BID ADDENDUM #6

Nanuet Union Free School District
103 Church Street
Nanuet, NY 10954

Nanuet Bond Projects Phase 4

Date: April 19, 2024

SHEET NAME:
FIRST FLOOR ENLARGED KITCHEN RCP DEMO ALTERNATE 2

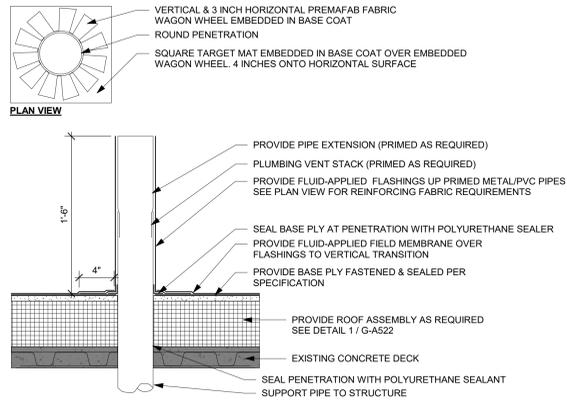
1. **Sheet HS-AD111.1: FIRST FLOOR ENLARGED KITCHEN RCP DEMO ALTERNATE 2**
 - A. Updated to reflect MC Alternate #2 and added note.
2. **Sheet HS-A111.1: FIRST FLOOR ENLARGED KITCHEN RCP ALTERNATE 2**
 - A. Updated to reflect MC Alternate #2 and added note.
3. **Sheet HS-A121: OVERALL ROOF PLAN**
 - A. Referenced only for coordination. Refer to MC-01 for scope of work.
4. **Sheet HS-A401.1: FIRST FLOOR ENLARGED PLAN – WEST ALT. 1**

INTERIOR EXISTING CONDITIONS PHOTOS K8
12" = 1'-0"

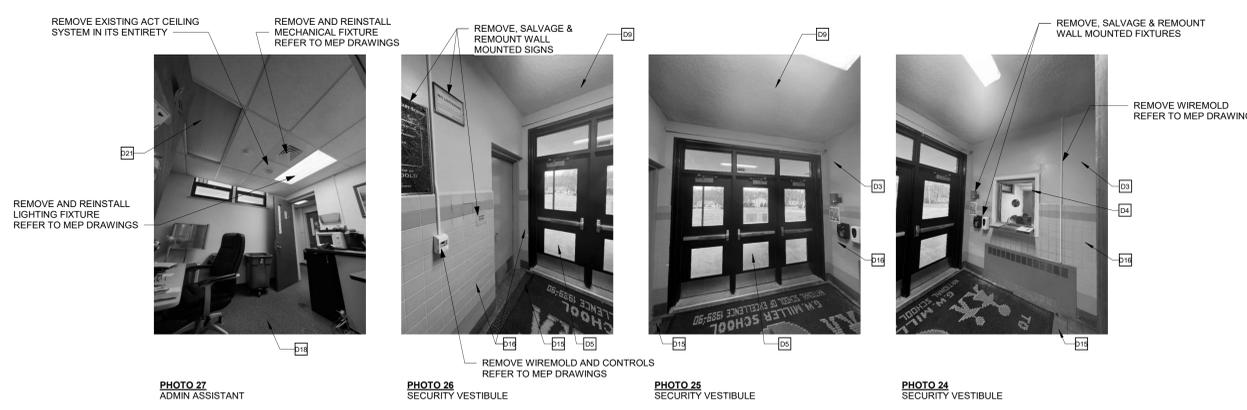
- A. Referenced only for coordination. Refer to MC-01 for scope of work.
- 8. **Sheet ME-AD000: REFERENCE PHOTOGRAPHS**
 - A. Updated Demo Keynote D8 and locations on photographs.

ROOF PLAN A7
1/16" = 1'-0"

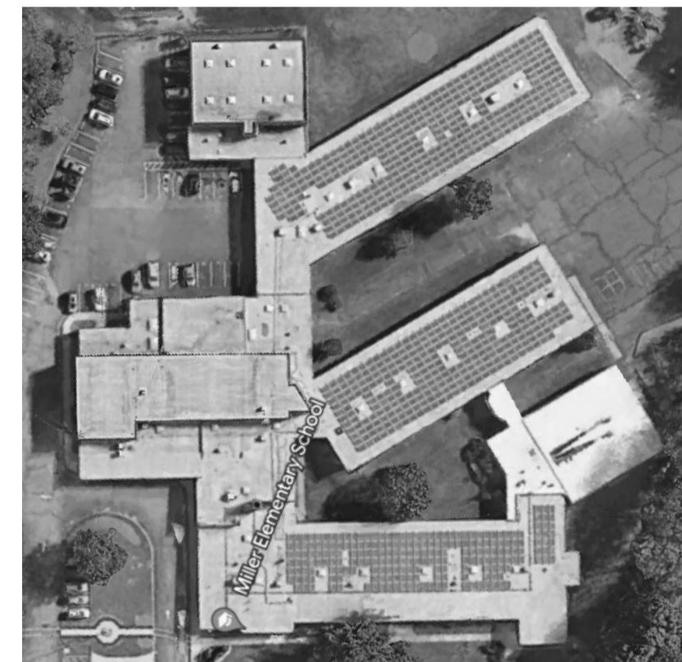
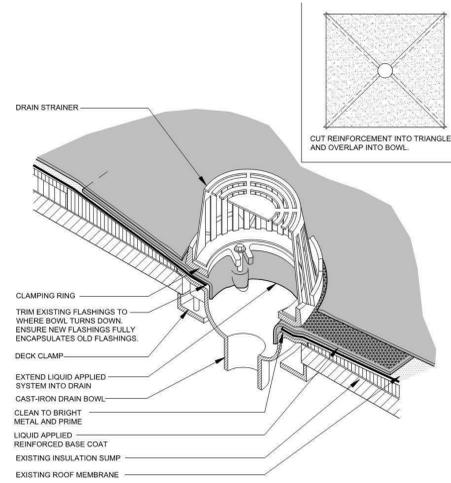
6. Refer to addendum #2, Contract BE-01 removed from bid package (New roofing at miller elementary school) but drawings "ME-A121 'Overall roof plan', ME-A521 'Fluid-applied roofing over exist. roof details' and ME-A522 'Roof details' are still not deleted. Please clarify that roofing work on above mentioned is a part of contract GC-01 or not?

- A. Updated doors with note #10.
- 11. **Sheet ME-A121: OVERALL ROOF PLAN**
 - A. Referenced only for coordination. Refer to MC-01 for scope of work.
- 12. **Sheet ME-A521: LIQUID APPLIED ROOFING OVER EXIST. ROOF DETAILS**

Response: New roofing is not a part of GC-01 contract. The drawings were left in for coordinating purposes for MC. However, any roof work at the HS, Middle School or Miller Elementary School related to mechanical equipment is by the MC. Refer to added roof sheets and specs for coordination.

REFERENCE ONLY FOR COORDINATION. REFER TO MC-01 FOR SCOPE OF WORK

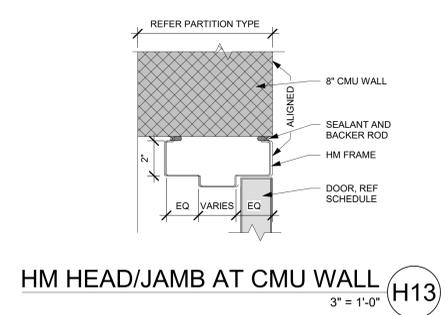
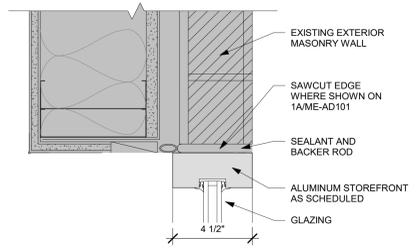
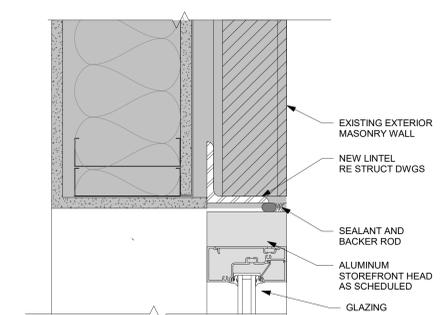
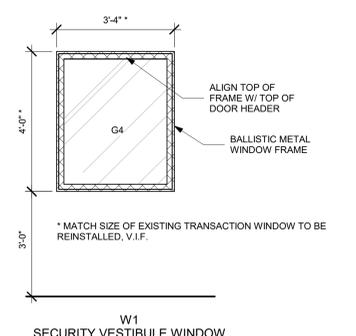
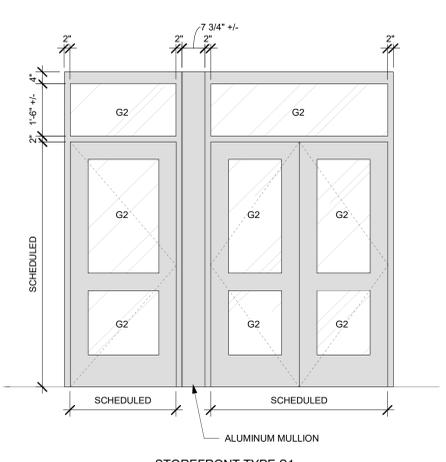
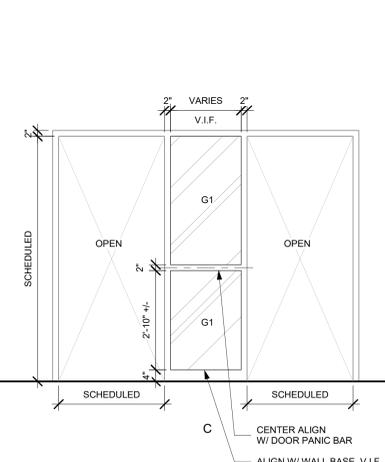
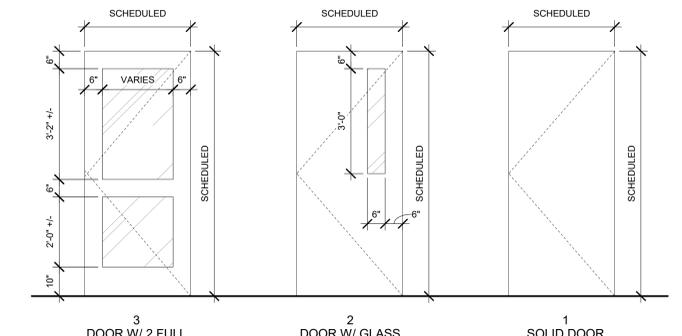
4. Refer to Key Note D8 on Drawing ME-AD101 and Key Note 11 on Drawing ME-A101. These key notes ask to replace door hardware with new panic hardware at existing doors #108, 109, 110, and 111. However, the door schedule on Drawing ME-A601 indicates new doors and frames at the aforementioned door locations. Please clarify if these doors are to be replaced or not?

5. Refer to key note 9, 10 at dwg. ME-A101 and key note D7 at dwg. ME-AD101. These key notes ask to replace door leaf and hardware, door frame to remain at doors #100, 101, 102, 103, 104, 105, 106 & 107. However, the door schedule on drawing ME-A601 indicates new doors and frames at the aforementioned door locations. Please clarify if these door frames are to be replaced or not?

- A. Referenced only for coordination. Refer to MC-01 for scope of work.
- 13. **Sheet ME-A601: DETAILS & DOOR SCHEDULE**
 - A. Updated door type and glass type for doors 106, 114 & 115.

Response: All doors receiving new panic hardware are to be replaced. Please refer to updated ME-AD101, ME-A101, and ME-A601.

Response: All doors receiving new hardware are to have new frames. Please refer to updated ME-AD101, ME-A101, and ME-A601.

OVERALL ROOF PLAN 1
1/16" = 1'-0"

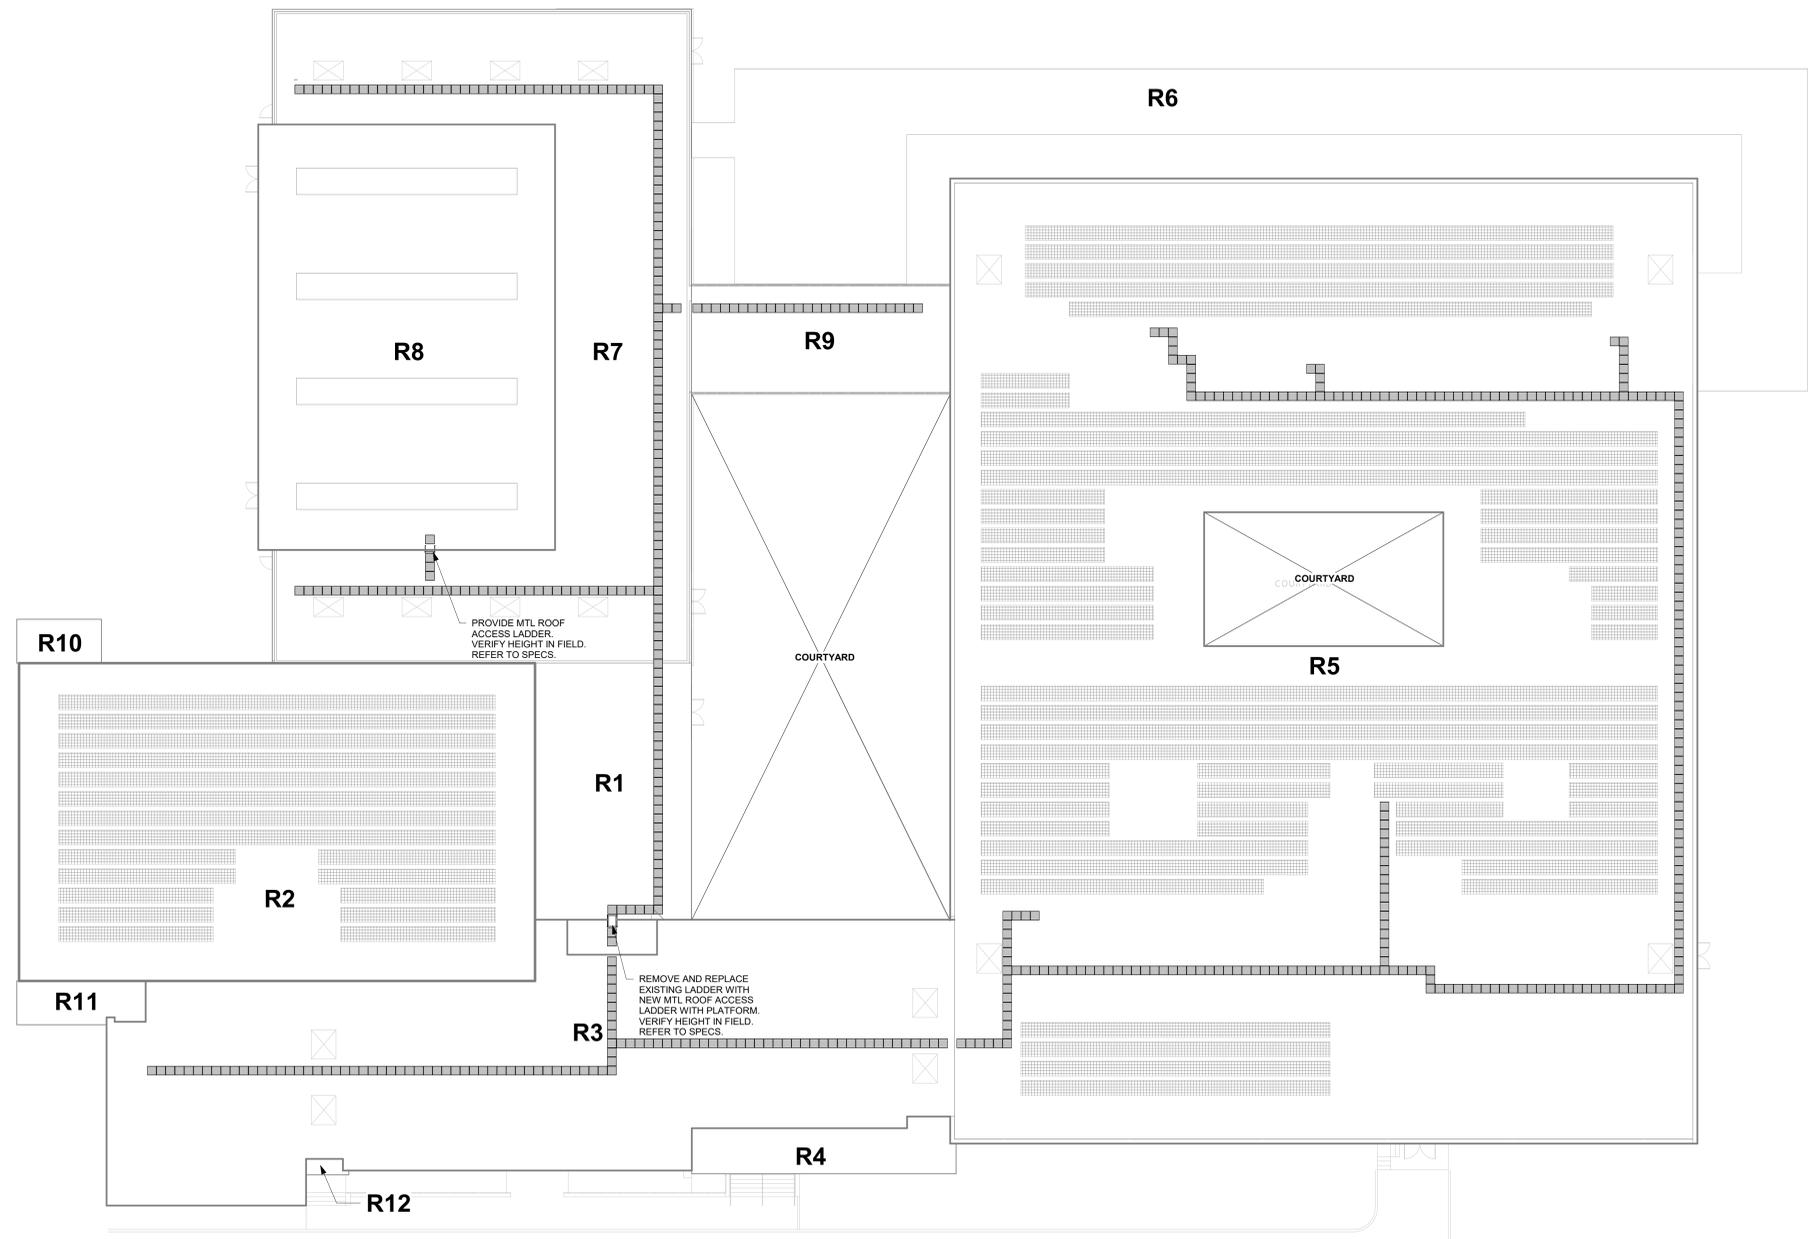
- 14. **Sheet BM-A121: OVERALL ROOF PLAN**
 - A. Referenced only for coordination. Refer to MC-01 for scope of work.
- 15. **Sheet BM-A521: LIQUID APPLIED ROOFING OVER EXIST. ROOF DETAILS**
